GENERAL CONSULTANT/AUDITOR

NATURAL GAS & QUALITY MEASUREMENT
OPERATIONS/DESIGN/SETTLEMENT AUDIT

Reference: Oil Conservation Division Case NO. 12520

Pursuant to your request, enclosed are exceptions to BP Amoco's Proposed Order of the Division for removal of the tubing in the Dakota wells and deep Gallup formations producing gas, condensate or water.

DK

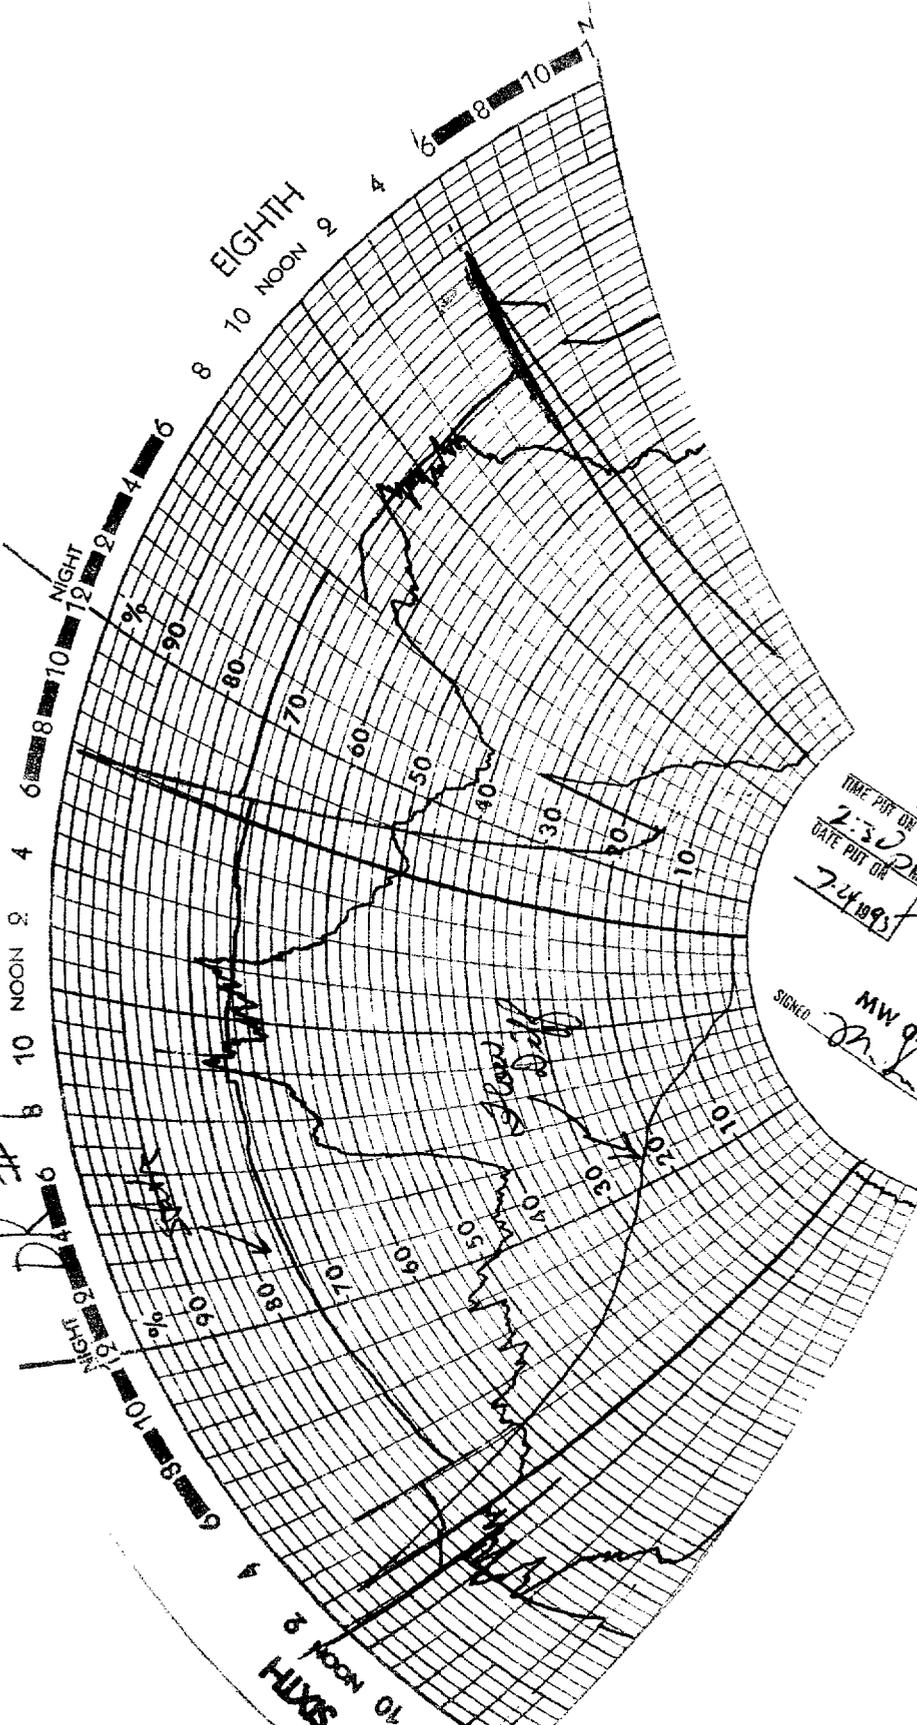
- DK #1 - Typical high production flow rates that never completely log off with gas bubbling through liquids until formation pressure builds up to unload well.

DK # 2

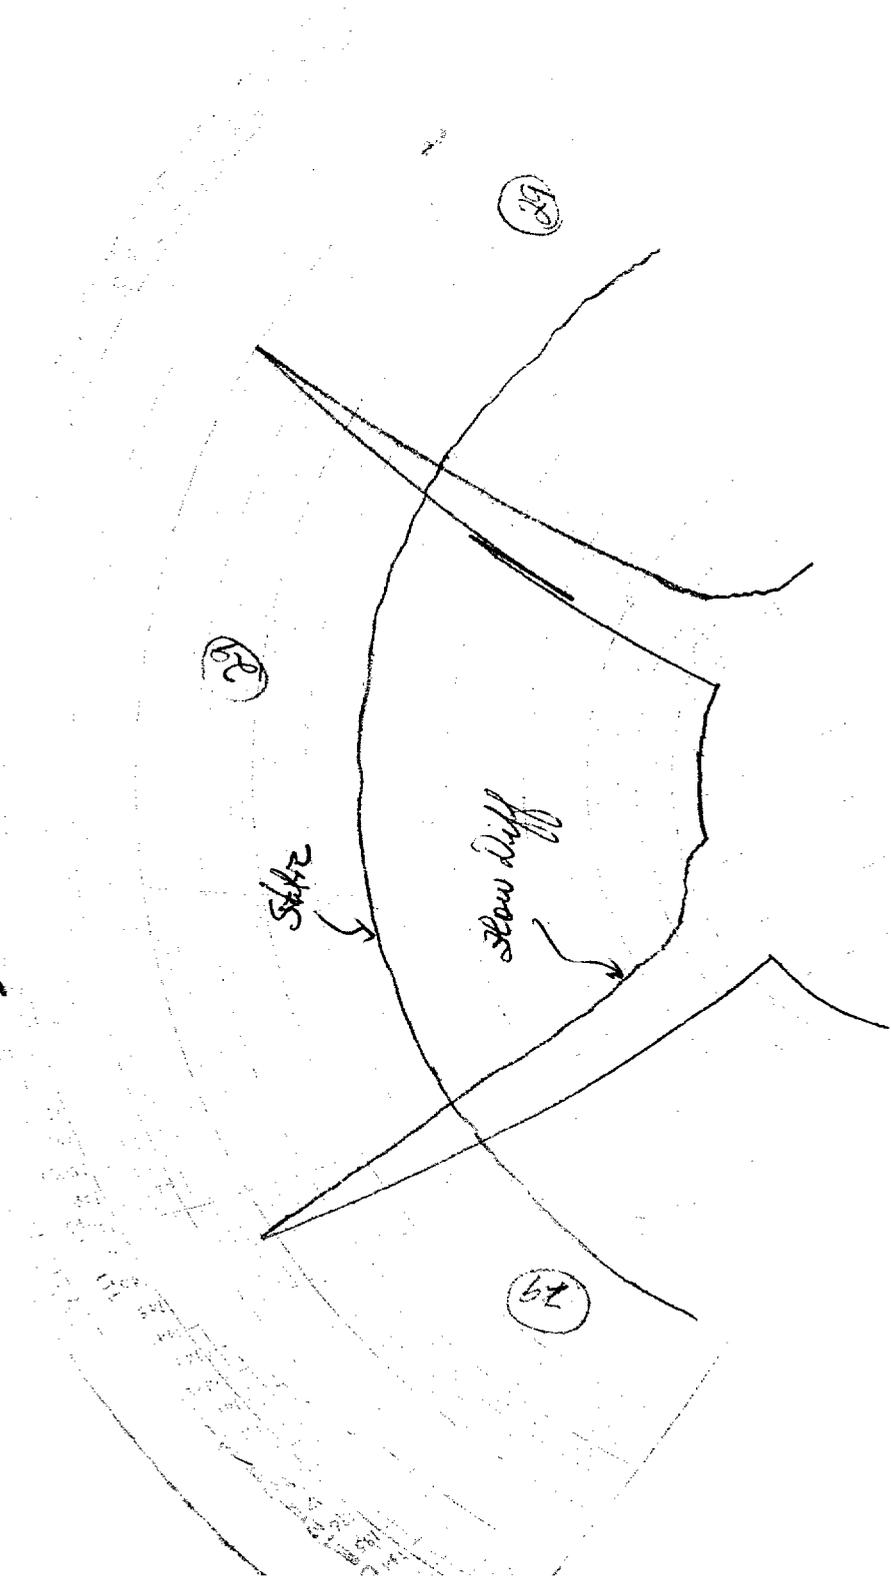
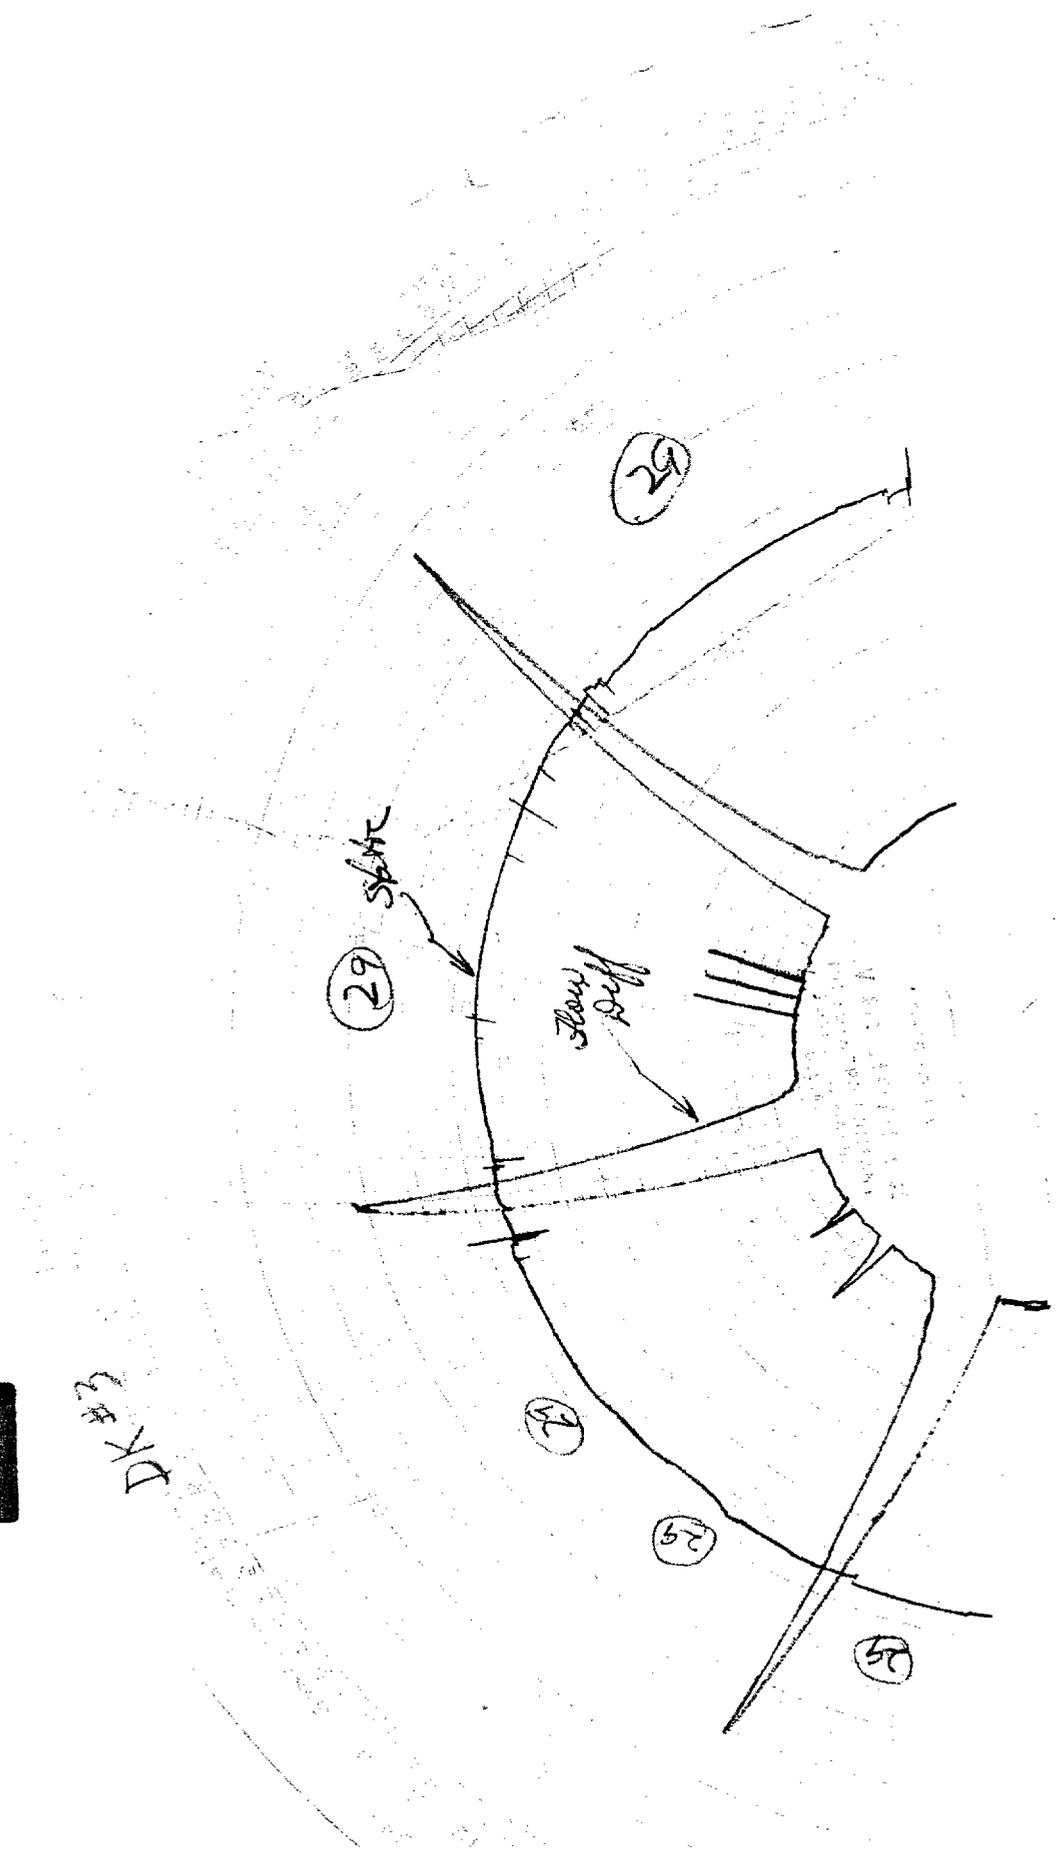
- DK #2 - Typical mid range flow rates that eventually log off (Code 29) and await formation pressure buildup to unload the well bore.
- DK #3 - Typical low range flow rates that rapidly log off (Code 29) and try to unload as bottom hole pressure increases; continued logged off until sufficient down hole pressure finally increases to periodically unload the well bore through the tubing.

DK # 4

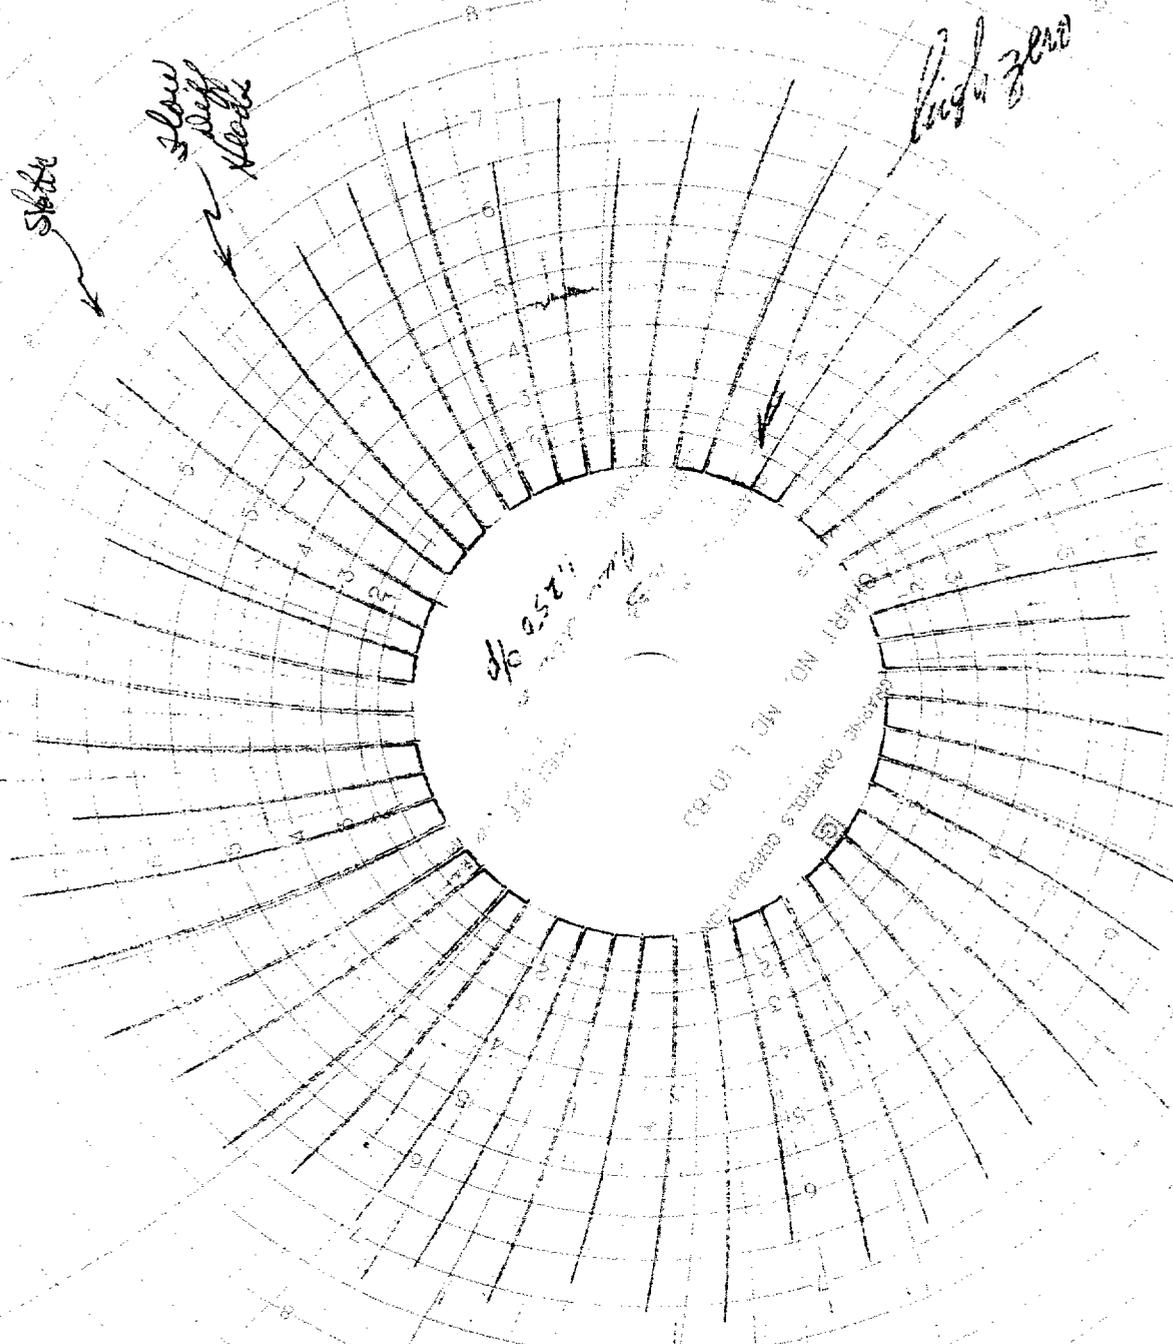
- DK #4 - Typical low flow range wells that utilize timed or pressure differences between tubing and casing to activate downhole piston travel to the surface lifting liquids with a burst of increased bottom hole pressure to provide energy for liquid lift (flow 15 minutes - off 3 hours 15 minutes to build up pressure).

PC #6

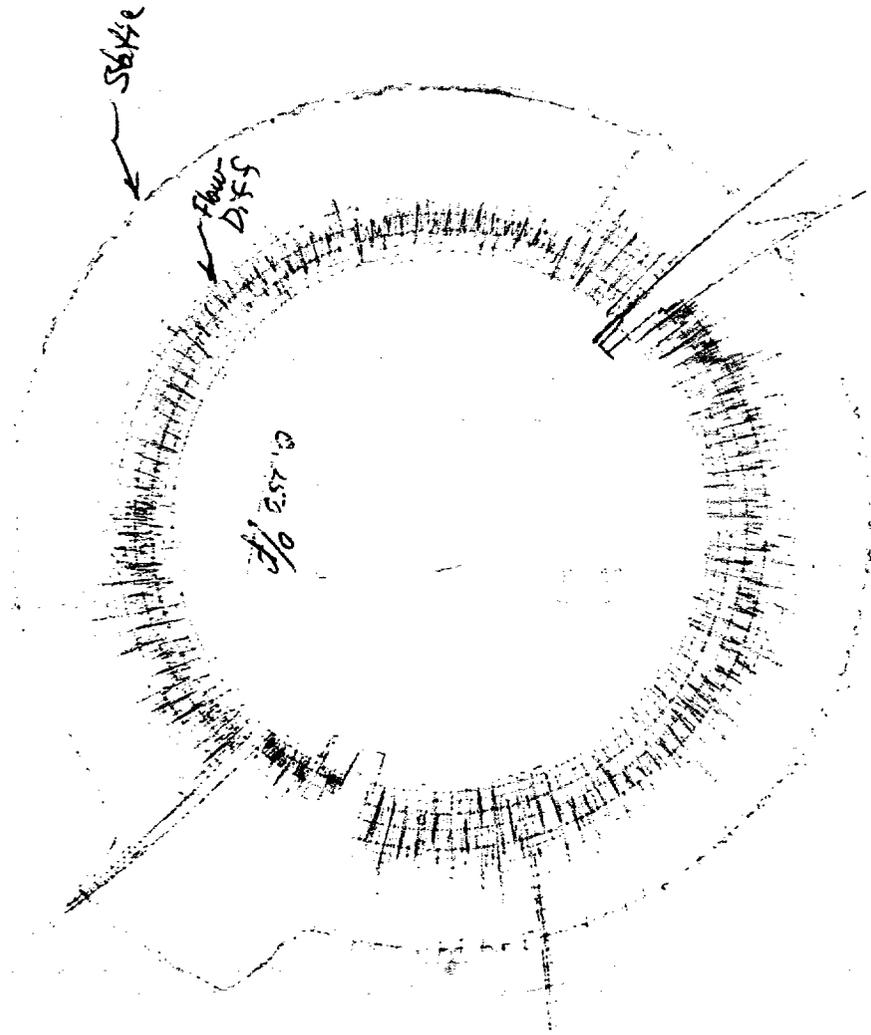
- PC #6 - Typical low flow Pictured Cliff formation production with horizontal well fractures that does not lend itself to immediate well logging off and which unload at lower flow rates through the tubing.
